**PROJECT NO. WS90400084
LIFT STATION 66 REFURBISHMENT**

ADDENDUM NO. 3

ISSUE DATE: Wednesday, August 23rd, 2023

CIVIL
12" WATER LINE
RESIDUALS PUMP STATION
YARD PIPING 1

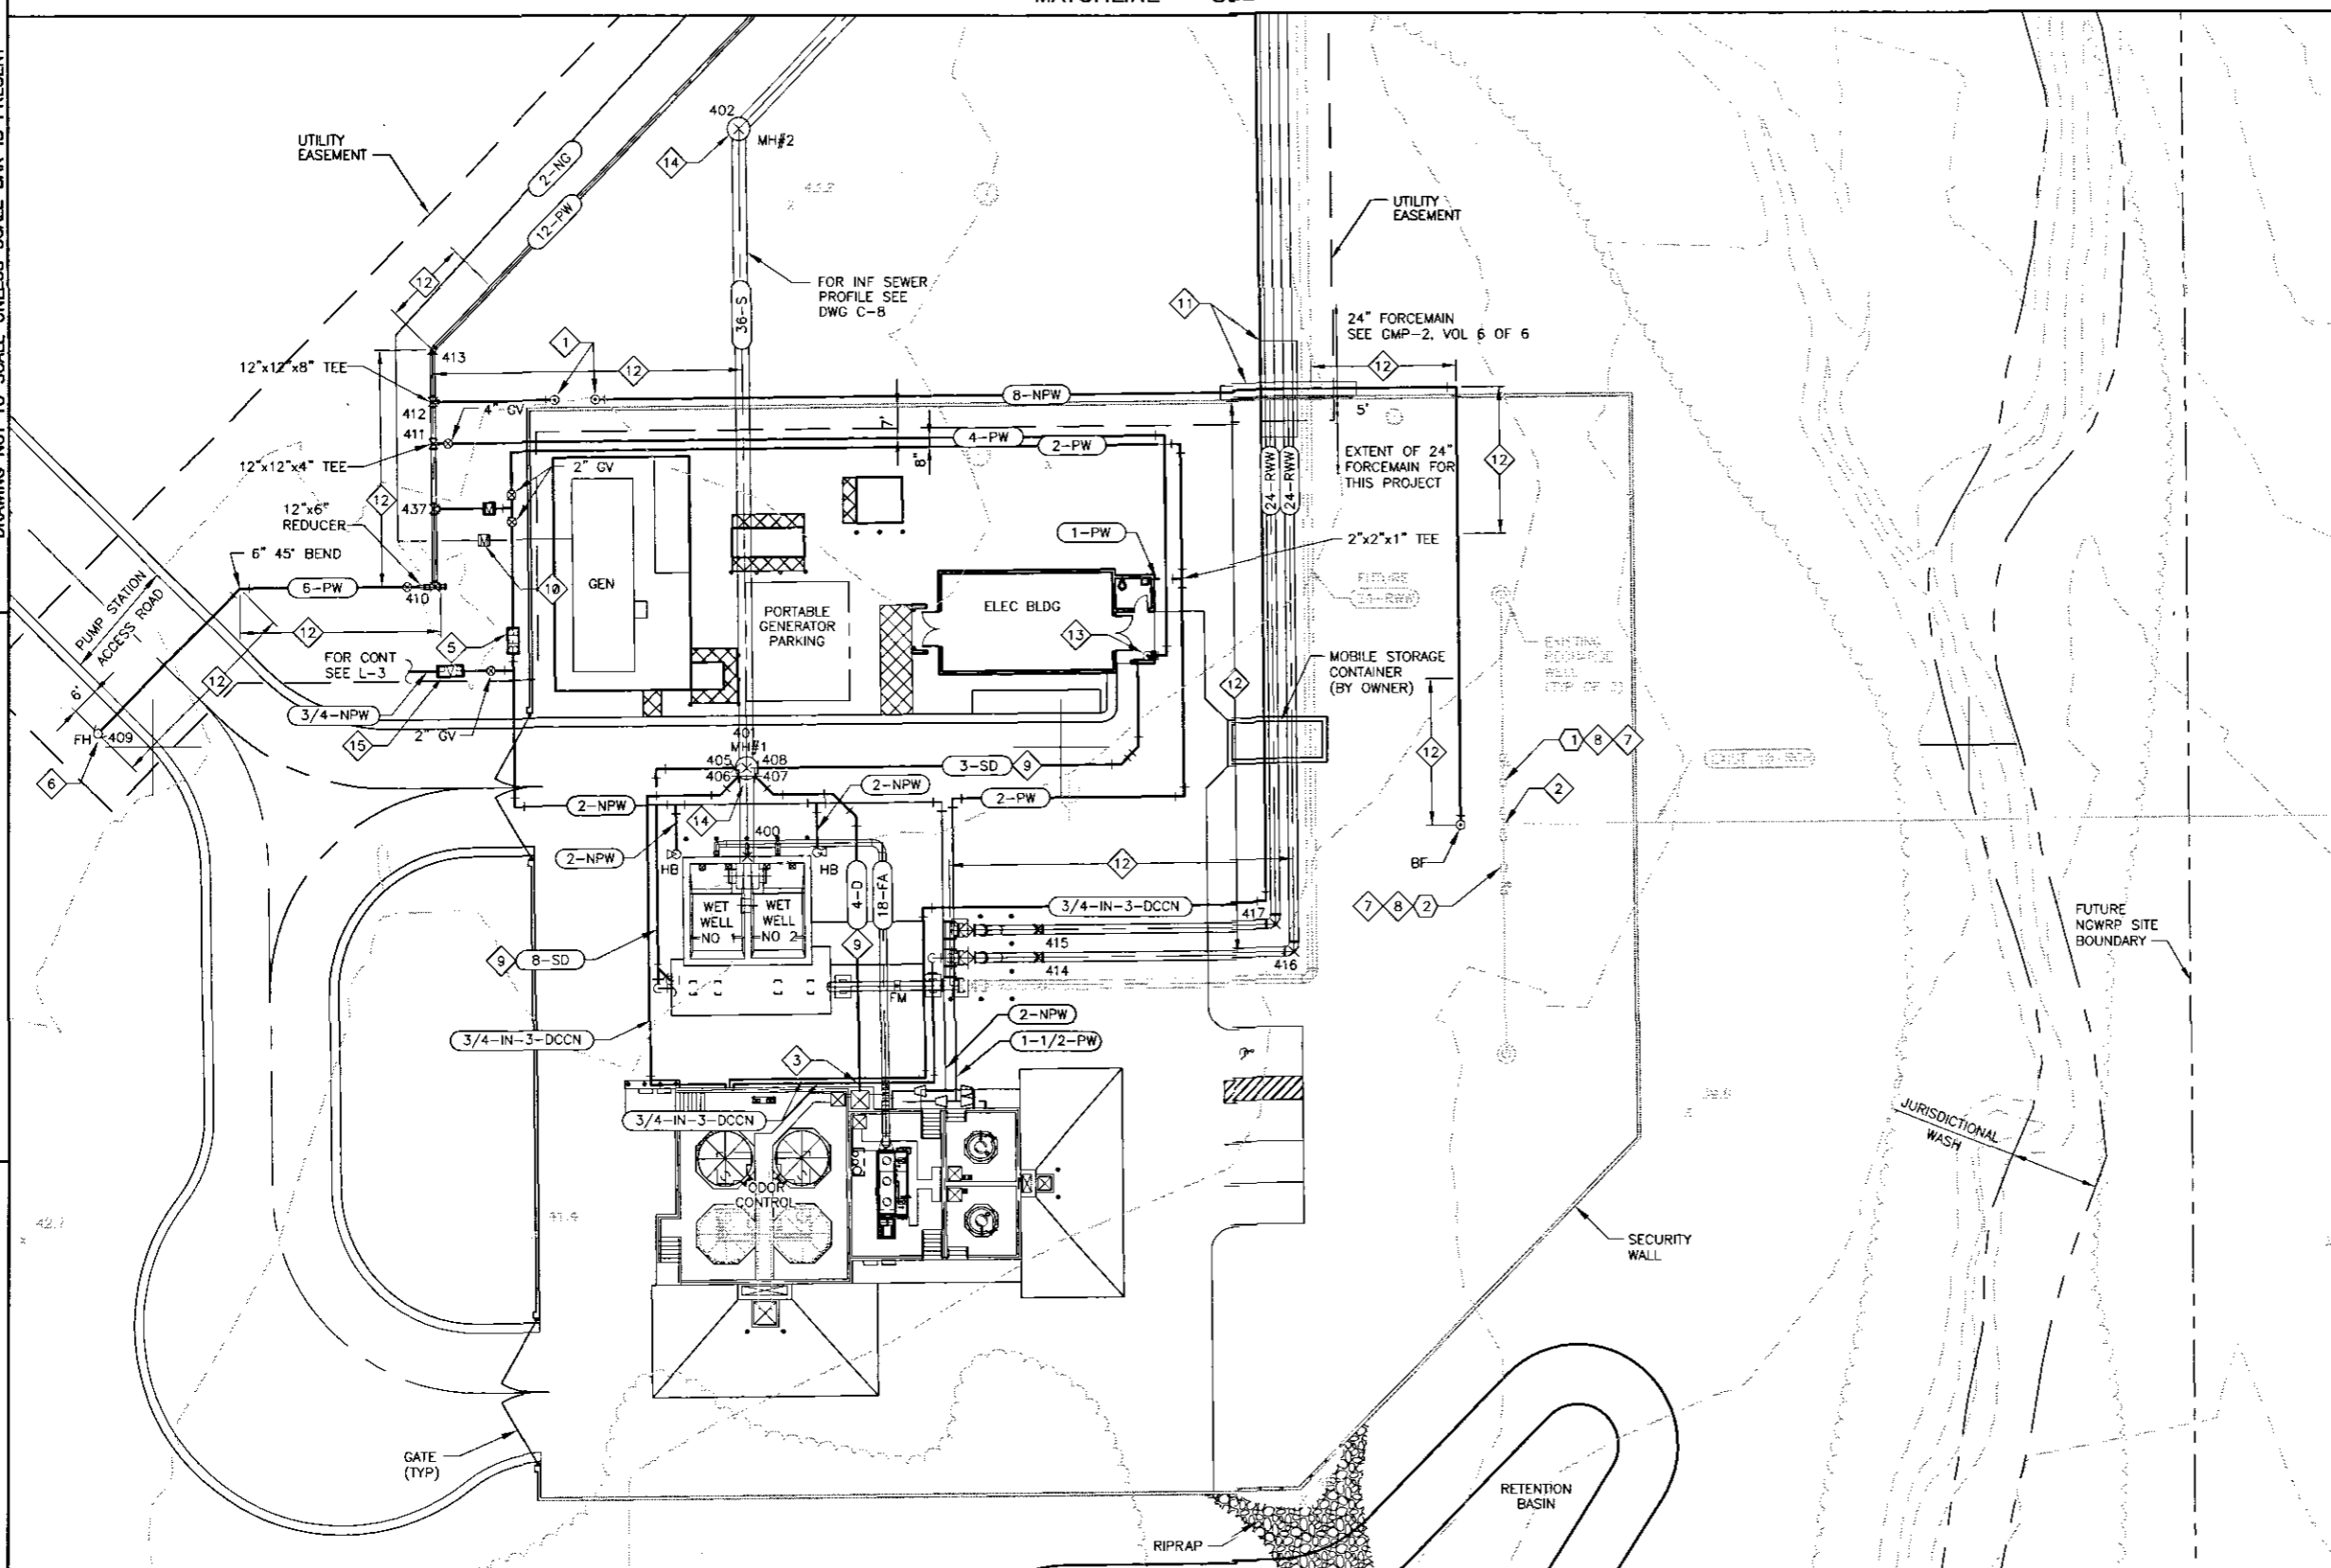
Q13.	Drawing page 39/80 – Note 5, where do these DCCN lines connect? How many lines are connecting? Drawing shows 3 but note 5 says 'line.' Please provide detail. See attached.
A13.	Three (3) lines are currently connected. The existing DCCN lines connect as follows: <ul style="list-style-type: none"> • One (1) line connects to the SS Manhole just north of the wet well area. • One (1) line runs North outside of the station and connects to a Diversion box. • One (1) line connects to the existing force main. Refer to attached as-built drawings for further clarification.
Q14.	Drawing 58/80 – At the top the DCCN lines are shown but it only shows 1 line. It also says to see continuation on drawings 36 and 49. No detail shown on 36. There is no continuation on 49. Please provide more detail. See attached.
A14.	Contractor shall reuse the existing line that runs to the current header and connect to the proposed header system shown on Sheet 39.

Items 13 and 14 regarding DCCN locations and connections:

- ADD:**
- Drawing C-4, As-Built, "12" WATER LINE RESIDUALS PUMP STATION YARD PUMPING 1" Dated 11/05.
- Drawing M-6, As-Built, "PUMP STATION ODOR CONTROL FACILITY PLANS" Dated 11/05.
- Drawing M-9, As-Built, "PUMP STATION ODOR CONTROL FACILITY DETAILS" Dated 11/05.
